Project
ENTOURAGE IN THE SUN
407 & 409 N RIVERSIDE,
POMPANO BEACH, FL 33062

Title
VARIANCES

Field
ARCHITECTURE
Scale
as shown
Date
10-19-2022
Project Manager
N. TREMBLAY
Project
22-800
Dwg. no.
A-014

VARIANCE 1 & 2
STAGING AREA BUFFERS STAGING AREA
A-014 SCALE: 1/8" = 1'-0"

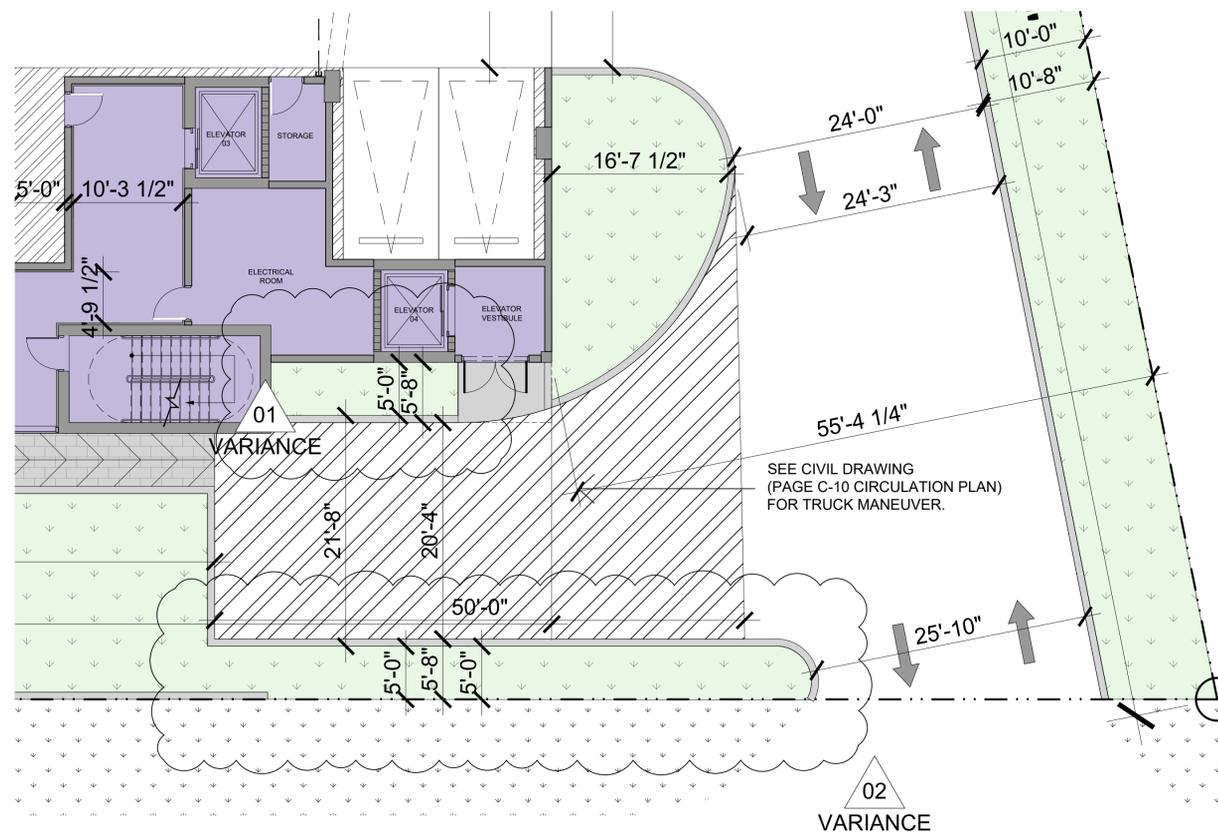
LANDSCAPE BUFFER BETWEEN STAGING AREA & EAST PROPERTY LINE

Previous DRC comment #7 remains. The required perimeter landscaping strip has not been provided between the east property line and the area labeled "Staging Area for Trash Collection & Fire Truck." Revise plans to provide the landscape strip at the front of the property between the driveway and the front property line, in compliance with the requirements of this Section, or seek relief.

LANDSCAPE BUFFER BETWEEN STAGING AREA & BUILDING

Previous DRC comment #8 remains. The required landscape area has not been provided between the building and the area labeled "Staging Area for trash Collection & Fire Truck." Revise the plans to provide the required landscape area in front of the building, between the building and the driveway, in compliance with the requirements of this Section, or seek relief.

5'-0" WIDE BUFFER AROUND THE STAGING AREA. SEE CIVIL DRAWING FOR THE TRUCK MANEUVER (C-10 CIRCULATION PLAN). AS WELL, SEE LANDSCAPE DRAWING FOR PROPOSED LANDSCAPE AND TREES AROUND THE STAGING AREA.

5'-0" WIDE BUFFER AROUND THE STAGING AREA. SEE CIVIL DRAWING FOR THE TRUCK MANEUVER (C-10 CIRCULATION PLAN). AS WELL, SEE LANDSCAPE DRAWING FOR PROPOSED LANDSCAPE AND TREES AROUND THE STAGING AREA.

VARIANCE-3
LANDSCAPED ISLAND NORTH OF PARKING
A-014 SCALE: 1/8" = 1'-0"

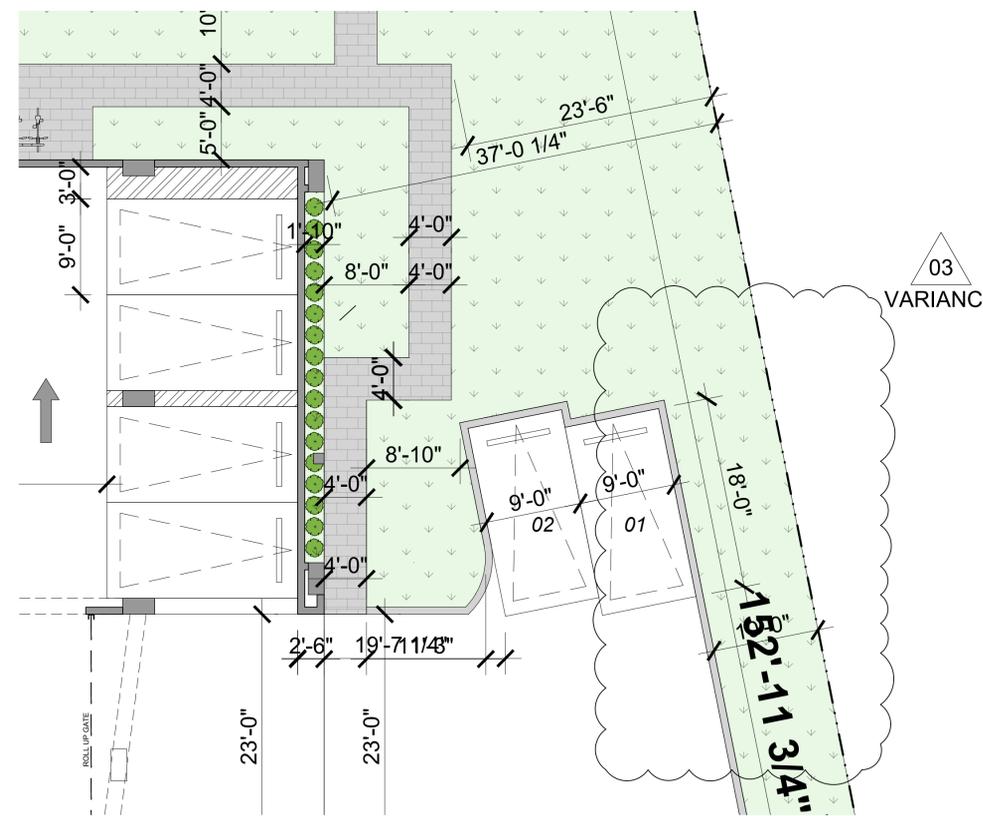
LANDSCAPE ISLAND ON THE NORTH SIDE OF THE 2 EXTERIOR PARKING SPACES.

b. Landscaped Islands in Parking Bays

A landscaped island shall be provided at each end of every row of parking spaces. Where a row of parking spaces contains ten or more parking spaces, additional landscaped islands shall be provided at a spacing no greater than one every ten parking spaces.

USING THE 10'-0" WIDTH PERIMETER LANDSCAPE AS THE LANDSCAPED ISLAND. ADDING A LANDSCAPED ISLAND TO THE NORTH OF THESE 2 PARKING SPACES WOULD REDUCE SIGNIFICANTLY THE LANDSCAPED ISLAND PROVIDED TO THE SOUTH OF THESE PARKING SPACES.
